10 CFR 50.46c Rule Making

Tom Eichenberg

Sr. Specialist, Reactor Safety Analysis, TVA

Webcast: 23 November 2015

Paragraph (k): Use of NRC Approved Fuel

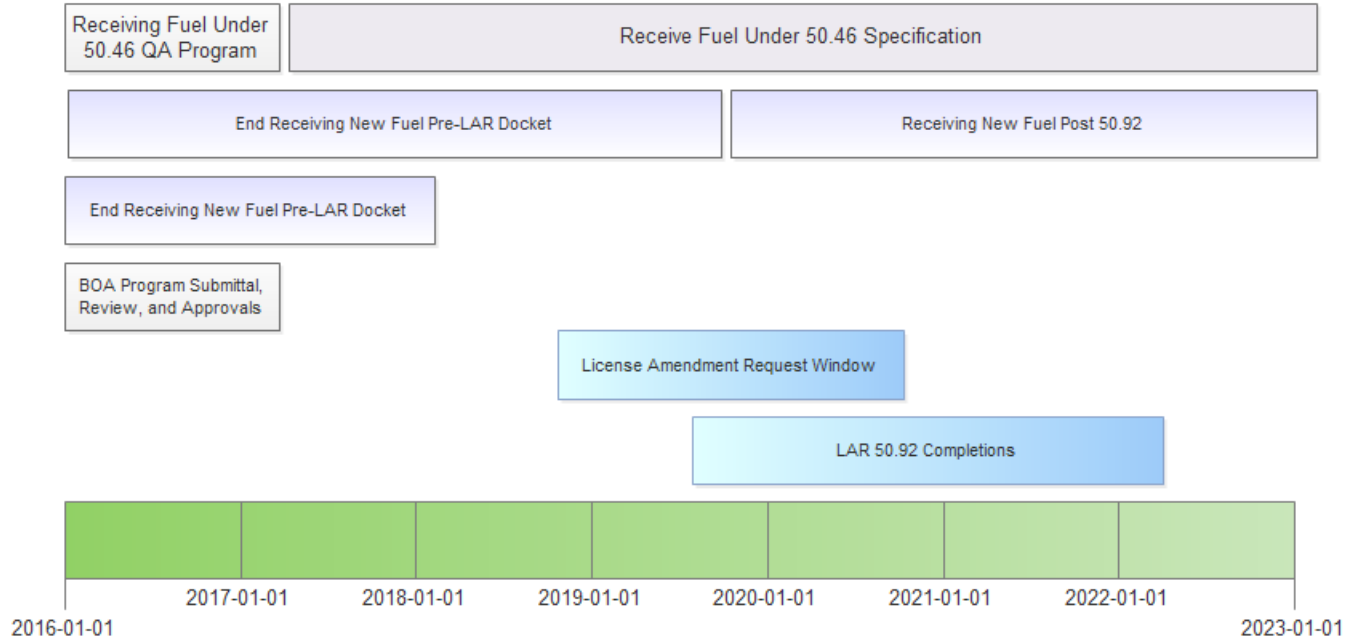
- All Fuel Must Demonstrate Compliance with Paragraphs (d) & (g)

- For uranium oxide and mixed uranium-plutonium oxide pellets within cylindrical zirconium-alloy cladding (i.e., current operating reactors), § 50.46c(k) invokes the fuel-specific analytical limits and requirements of § 50.46c(g) to approve fuel loading and reactor operation
- § 50.46c(g)(1) requires that such fuel be “. . . designed and manufactured . . .” to meet certain requirements, including confirmatory testing of breakaway oxidation behavior
- ***Strict interpretation of proposed language suggests that fuel manufactured before implementation of NRC-approved breakaway oxidation (BAO) testing programs would, at some point in time, be unacceptable for use in reactor cores***

- Prevent misinterpretation of § 50.46c(k) requirements by modifying § 50.46c(g)(1)
- “. . . Fuel consisting of uranium oxide or mixed uranium-plutonium oxide pellets within cylindrical zirconium-alloy cladding must ~~be designed and manufactured to~~ meet the following requirements: . . .”
- Modify Regulatory Guide 1.224 to address all fuel that may be manufactured prior to implementation of NRC-approved BAO testing programs, both irradiated and unirradiated
